RECEIPT DATE: 4/5/18 **ONSITE SEWAGE DISPOSAL SYSTEM** P 562950-C
 APPROVAL DATE: 4/19/18 sec **PERMIT: CONSTRUCTION** A _____

RE: Five Hills Farm, Lot 1
13880 Old Frederick Rd.
Sykesville MD, 21784
"Septic System Comments"

RE: Five Hills Farm, Lot 1
13880 Old Frederick Road
Bldg Permit #B17001552
Septic Plan

SEPTIC PLAN
FIVE HILLS FARM, LOT 1

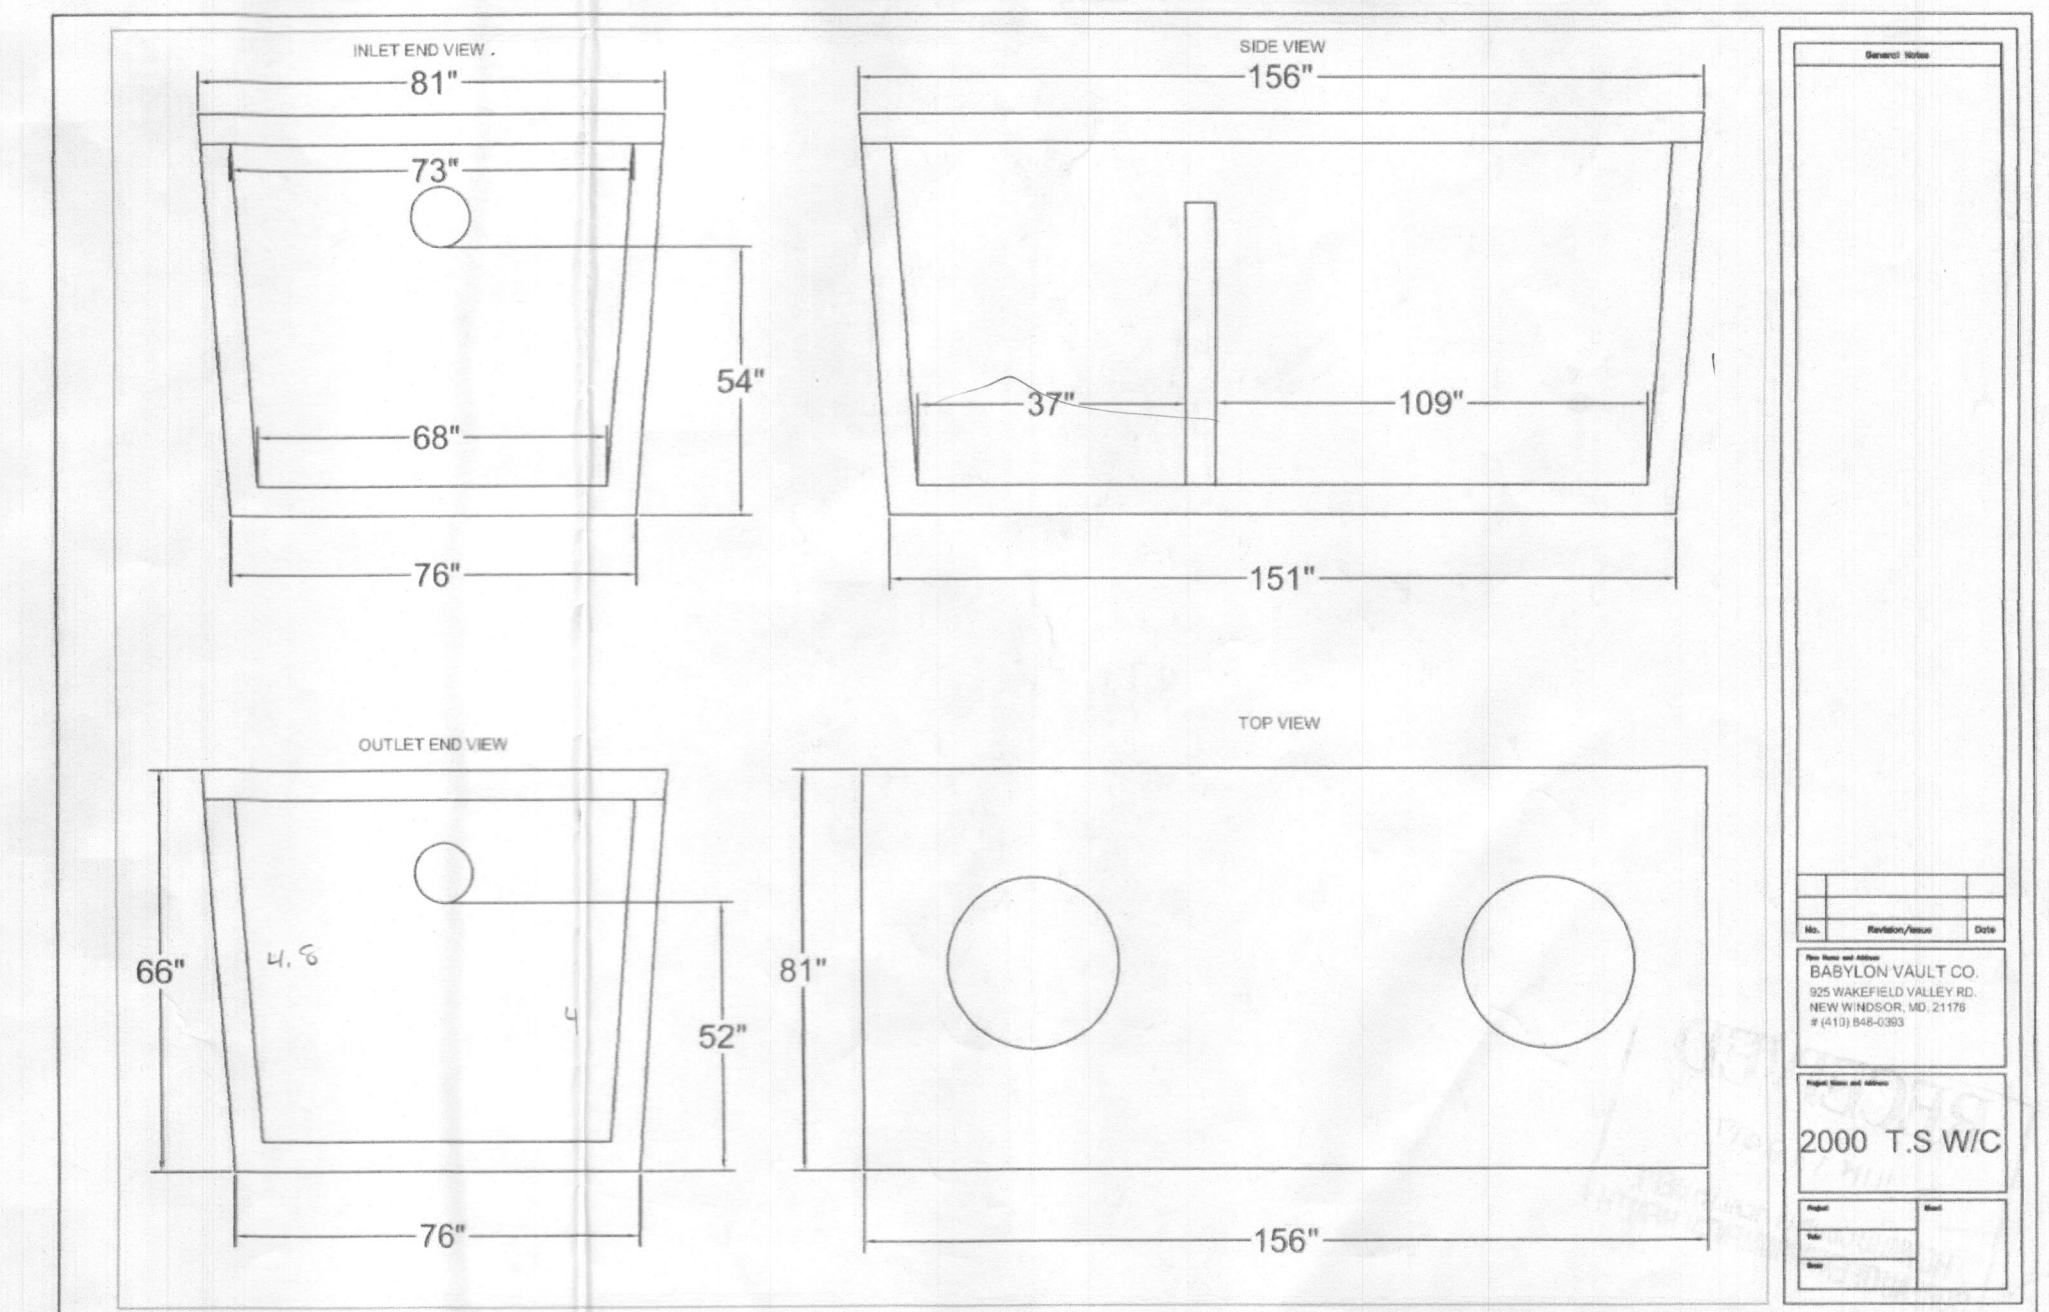
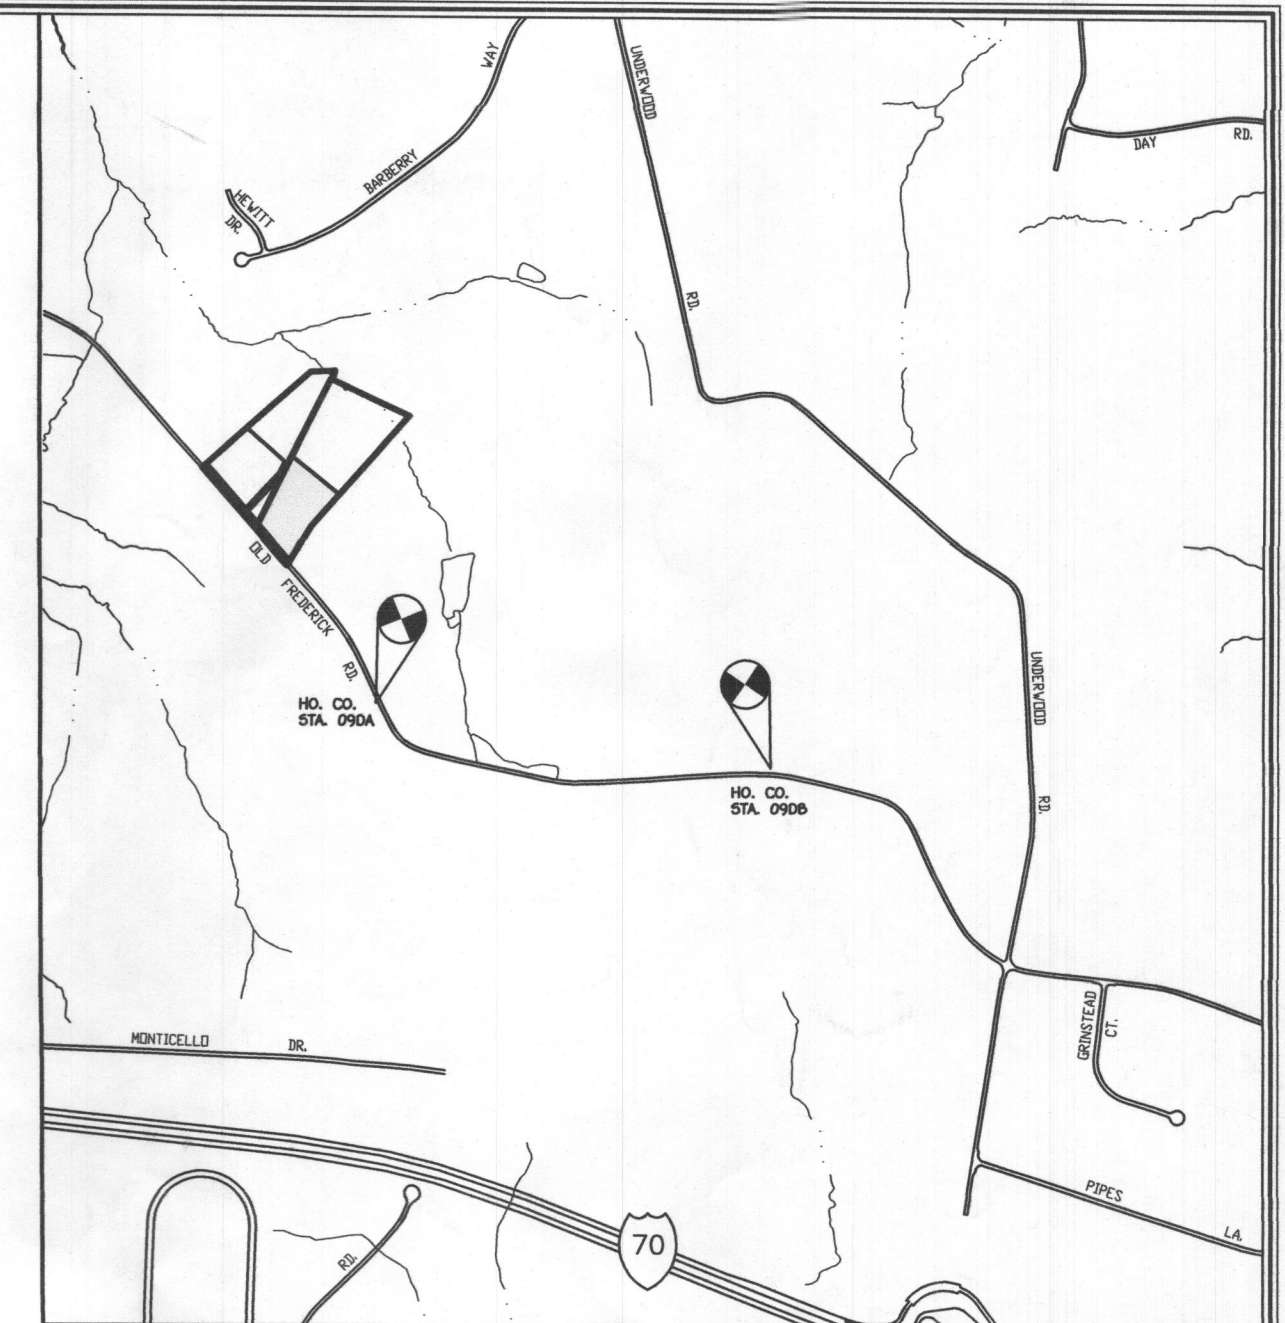
- Designing the systems main line (house to tank) to span over 240ft with 1% fall leaves little to no room for error during installation. If during installation the designed fall cannot be achieved a pump tank or heavy load bearing tank may be required. It is recommended the fall be increased to 2%. One possible way to increase fall could be to ask the builder if a hung sewer could be placed on the Southeast side of the house. If the decision is to keep the septic line as is the following note must be added to the plan, "If the house elevation and/or field elevations change from the designed septic plan a new septic plan will be required."

- The D-box needs to be closer to the edge of the SDA and not in the middle. Having the D-box closer to the septic tank could allow for more fall between the D-Box and trenches.

- The "Ex. Ground at Septic Tank" is not 559.14' based off of the Septic Profile.
- The "Ex. Ground at Distribution Box" is not 561.9' based off of the Septic Profile.

- The trenches are miss labeled or inconsistent in there labeling.
- The pool needs to be labeled and indicated whether it is to remain or to be removed.

1. System has been modified to show piping at 1.44% to gain some flexibility. Note regarding possible change in field elevations has been added as requested since desire is to not pump the system.
2. Distribution box has been moved to the easement edge as requested.
3. Existing ground at septic tank has been revised.
4. Existing ground at distribution box has been revised.
5. Labeling of trenches has been revised.
6. Pool has been labeled to be removed.
